SERVICE POINTER

L8178694A
October 2007

WHIRLPOOL CABRIO AND MAYTAG BRAVOS WASHERS

CLOTHING TANGLING AND BALLING

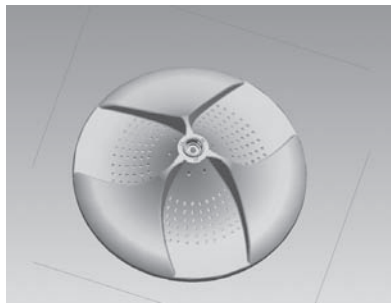
Clothing in the washer can become tangled and twisted or balled up.

Under certain conditions, a combination of the wash load, the cycle selected and the subsequent load movement can cause the load to become tangled or twisted.

Old Impeller

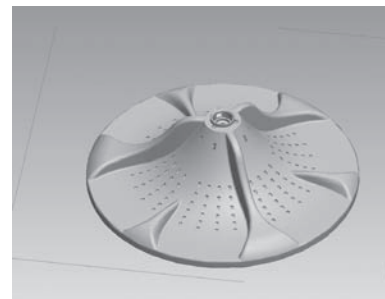
The wash impeller has been redesigned to make the wash load less likely to tangle under the conditions mentioned above. Replace the wash impeller with part #W10141017.

Check the part number on the electronic control. If it is 8576386, W10104830, W10112112 or W10112113, replace the control with the current part number substitution.

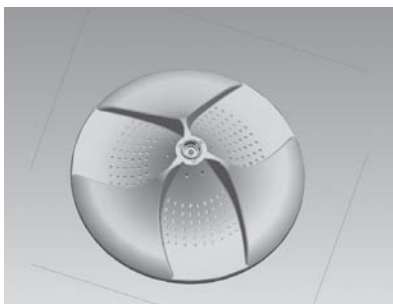
La ropa en la lavadora se puede enredar y retorcer o hacerse un ovillo.

Bajo ciertas condiciones, una combinación de la carga de lavado, el ciclo seleccionado y el movimiento posterior de la carga pueden causar que la carga se enrede o retuerza.

Impulsor anterior

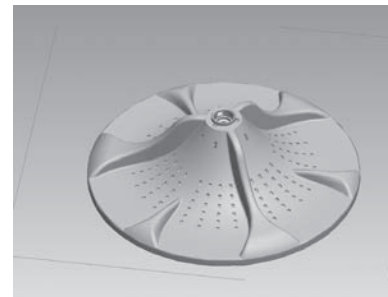
El impulsor de lavado ha sido rediseñado para que sea menos probable que la carga se enrede bajo las condiciones mencionadas arriba. Reemplace el impulsor de lavado con la pieza N° W10141017.

Verifique el número de pieza en el control electrónico. Si es 8576386, W10104830, W10112112 ó W10112113, reemplace el control con el sustituto del número de pieza actual.
